UNITED STATES PATENT AND TRADEMARK OFFICE

10/803,730

Office Action Summary	Application No. 10/803,730	Applicant(s) BUSAM ET AL.	
	Examiner SARA ADDISU	Art Unit 3724

DETAILED OFFICE ACTION

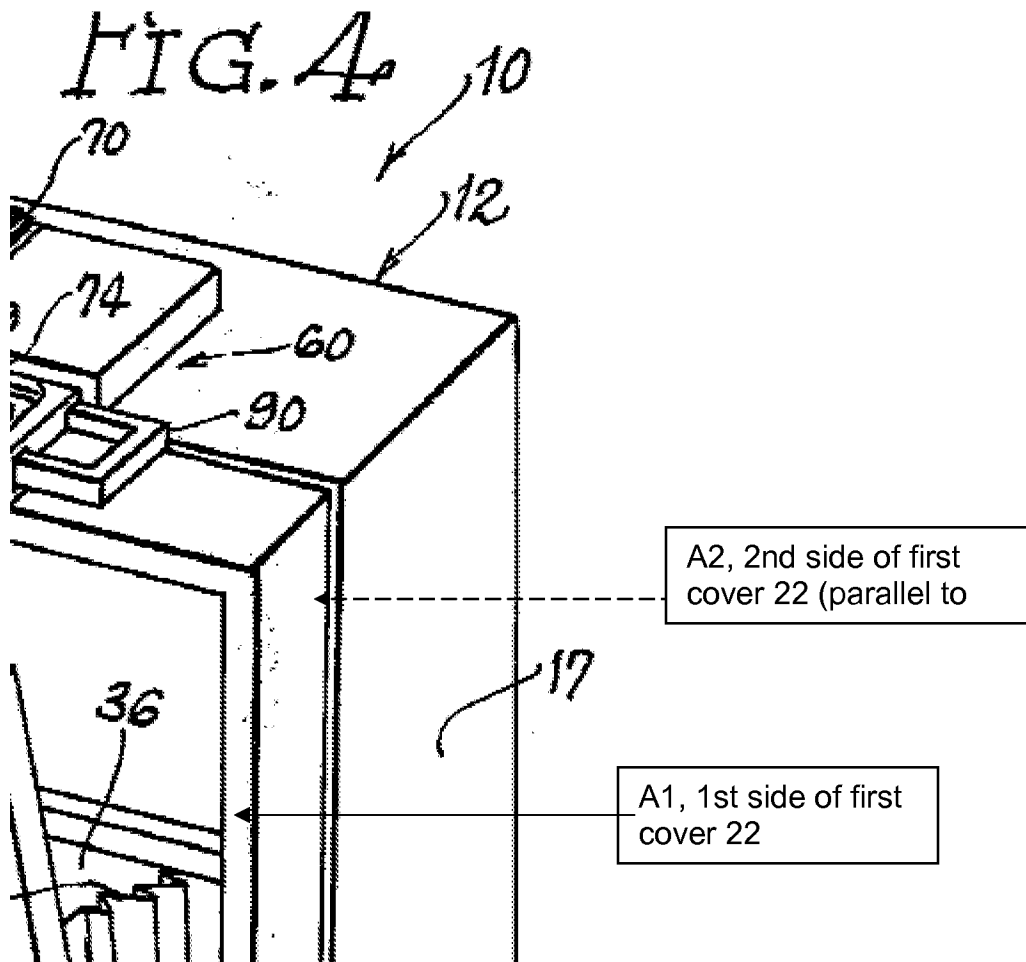
MALOOLY teaches a first cover (22) pivotally coupled to a second cover (12), both of said covers being generally flat and planar; said first cover including an opening (36) and having a first side (A1) and a second side (A2 being parallel to A1: see figure

below); and a pocket coupled to said first cover and generally received in said opening, said pocket including a first panel (26) and a second panel (42) defining a pocket cavity there between, said first panel (26) being larger than said opening (see figures 1 and 4) and at least portions or tabs (54) of the second panel (42) extending outwardly beyond said opening (see figures 1-4 and col. 3, lines 5-20). MALOOLY also teaches a first releasable fastening mechanism (32) positioned to releasably join said first panel (26) and said first side of said first cover (22) (see figures 1 and 4). Furthermore, regarding claim 22, MALOOLY teaches the second panel (42) is preferably provided with stop means to engage the ledges or stop elements (50), so as to prevent the second panel (42) from swinging out of the first cover (22) ('055, col. 3, lines 7-10). Regarding claims 23 and 24, MALOOLY teaches in figure 1, the pocket and its cavity being accessed from the outside and in figure 3, the pocket being accessed from the inside of the first cover. Regarding claim 25, when the first panel fastening mechanism (32) is undone, the first panel (26) can be pivoted away from the front cover 22 to its position shown in figure 1 whereby this configuration, the first panel (26) pulls the side panels (46) and portions of the pocket and pocket cavity through the opening (36) of the front cover (22) such that generally all of the pocket cavity is located on the first side (A1) of the first cover (22) and generally no portion of the pocket cavity is located on the second side (A2) of the first cover (22) thus, portions of the pocket and pocket cavity are pulled to the first side (A1) of the first cover (22) such that the pocket cavity can be accessed and components can be placed into and removed from the pocket /pocket cavity by a user without having to reach through or break a plane formed by the first cover (22).

Similarly, when it is desired to access the pocket from the second side (A2) of the first cover (22), the second panel (42) is pivoted inwardly (as shown in figure 3) thereby pulling portions of the side panels (46) and pocket cavity through the opening (36) such that in this manner, portions of the side panels (46) and pocket cavity are located on the second side (A2) and inwardly of the plane of the first cover (22) so that components can be added to or removed from the pocket cavity without a user having to reach to the first side (A1) or reach across or break the plane of the first cover (22). In this position, generally the entire pocket cavity is located on the second side (A2) of the first cover (22). Regarding claim 31, figure 1, shows the first panel (26) pivoting independently and figure 3 shows the second panel (42) pivoting independently. Please note that, although MALOOLY is a suitcase and not a binder, Examiner stresses that it functions the same way as a binder which is to act as a means of storage thus reads on the claims.
